# UNITED STATES PATENT AND TRADEMARK OFFICE

APPLICATION NO.	FILING DATE	FIRST NAMED INVENTOR	ATTORNEY DOCKET NO.	CONFIRMATION NO.
10/644,372	08/20/2003	Patrick H. Buffet	RPS920030106US1	6420
47052	7590	11/17/2004	EXAMINER	
SAWYER LAW GROUP LLP			THAI, LUAN C	
PO BOX 51418			ART UNIT	PAPER NUMBER
PALO ALTO, CA 94303			2829

**Office Action Summary**

**FIG. 17A**

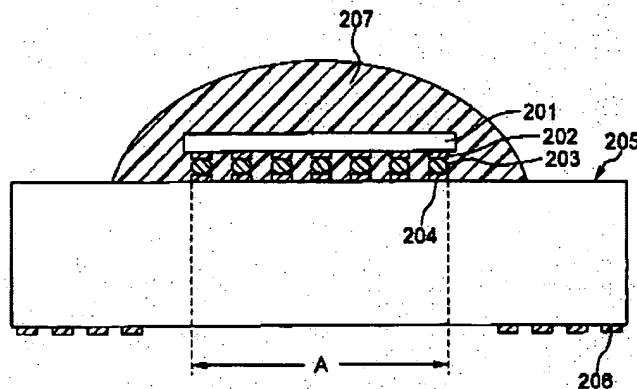
Regarding claims 1, 4-7 and 11-17, Arima et al (see specifically figures 1-2 and 17A attached) disclose a multi-layer semiconductor chip package, comprising:

a first pair of conductors (X) for carrying a first signal in a layer of a carrier (205 of figure 17A) having a similar terminals arrangement as shown in figure 1 (Col. 8, lines 8-50); a second pair (Y) of conductors for carrying a second signal adjacent to the first pair of conductors in the layer, wherein the second pairs of conductors (Y) is positioned to be orthogonal to the first pair of conductors (X) and equidistant to each conductor in the first pair of conductors (X) and wherein the layer is near an interface between the carrier and a chip (see figure 17A). By forming the package as described above, even if signal wiring

are closely arranged, it is possible to prevent cross-talk from occurring and it is possible to prevent the size from (see the Abstract and Col. 2, lines 1-4, Col. 6, lines 16-25, Col. 8, lines 1-7, Col. 9, lines 41-44, Col. 10, lines 5-9, and Col. 12, lines 42-45).

**FIG. 2**

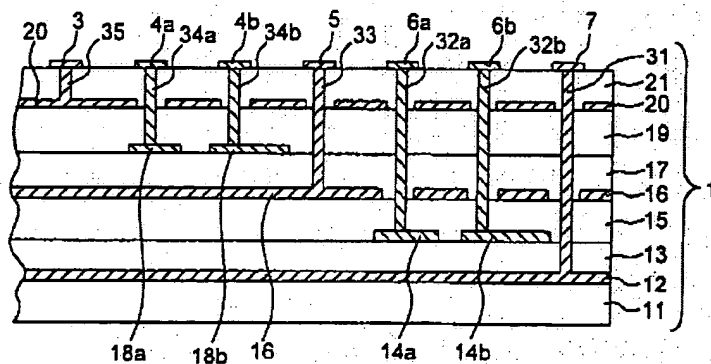
Regarding claims 2, 8, 10 and 19, Arima et al further teach a height (e.g., 34a-34b in figure 2) of the 1<sup>st</sup> pair "X" being substantially shorter than a height (e.g., 32a-32b in figure 2) of the 2<sup>nd</sup> pair "Y".

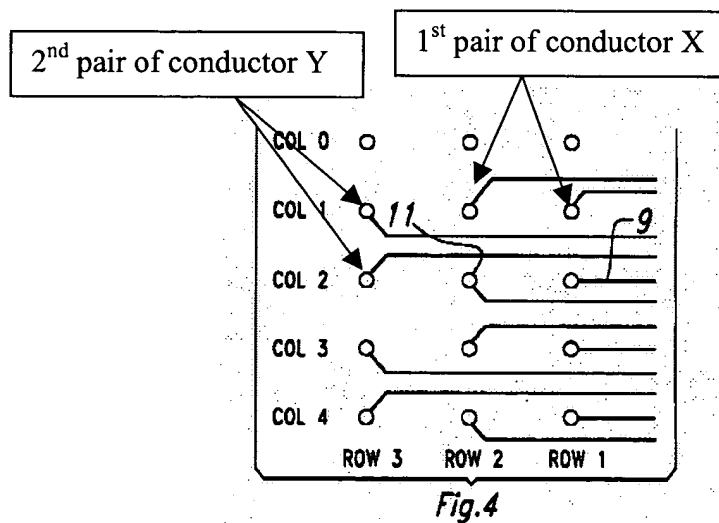
Regarding claims 1, 4-5, 11, 13, and 15-16, Stearns et al (see specifically figure 4 attached and Col. 2-3) disclose a multi-layer semiconductor chip package, comprising:

a first pair of conductors (X) for carrying a first signal in a layer of a carrier (1) of the package; a second pair (Y) of conductors for carrying a second signal adjacent to the first pair of conductors in the layer, wherein the second pairs of conductors (Y) is positioned to be orthogonal to the first pair of conductors (X) and affect each other evenly. Stearns

et al. teach that the advantages of the layout described above are: improved electrical performance, suitability for high frequency applications and flexibility to use nearly all signal traces as differential pairs or single ended lines and reduced cross talk (see Col. 2, lines 56+).

FIG. 10

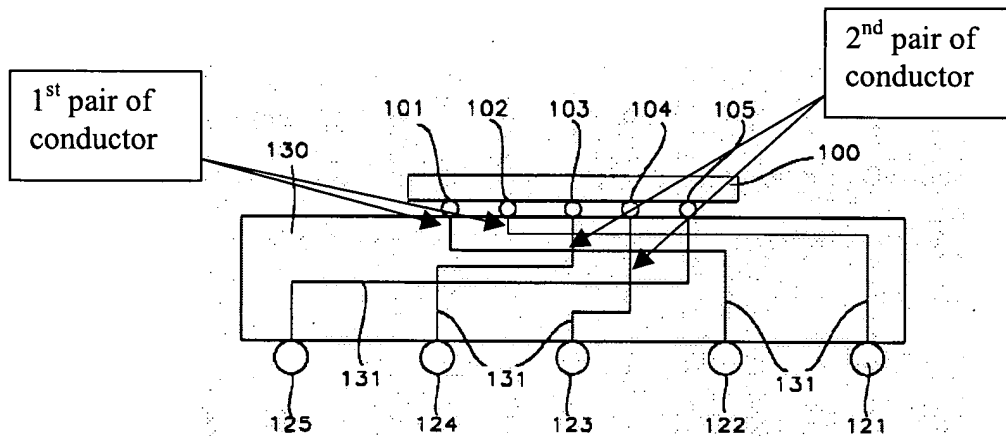
Regarding claims 1-3, 7-11, and 14-16, Lin discloses (see specifically figures 10) a multi-layer semiconductor chip package, comprising: a first pair of conductors, which are the vertical wirings 131 connected to bumps 101-102, for carrying a first signal in a layer of a carrier (130) of the package, wherein the layer is near an interface between the

carrier (130) and a chip (100); a second pair of conductors, which are the vertical wirings 131 connected to bumps 103-104, for carrying a second

signal adjacent to the first pair of conductors in the layer, wherein a height of the first pair of conductors (e.g., the vertical wirings 131 connected to bumps 101-102) is substantially shorter than a height of the second pair of conductors (e.g., the vertical wirings 131 connected to bumps 103-104), and wherein the height of the second pair of conductors in a subsequent layer (e.g., the vertical wiring 131 connected to contact points 123-124) of the carrier is shorter than the height of the first pair of conductors in the subsequent layer (e.g., the vertical wiring 131 connected to contact points 121-122). Thus, all the claimed structure of the invention has been taught. Lin does not explicitly disclose cross-talk between the first and second pairs of conductors being substantially minimized.

Since applicant's claimed structures in claims 1-3, 7-11, 14-16, 18-21 and 24 do not distinguish over the Lin reference, the claimed of "cross-talk being substantially minimized" could have been included in Lin's structure.
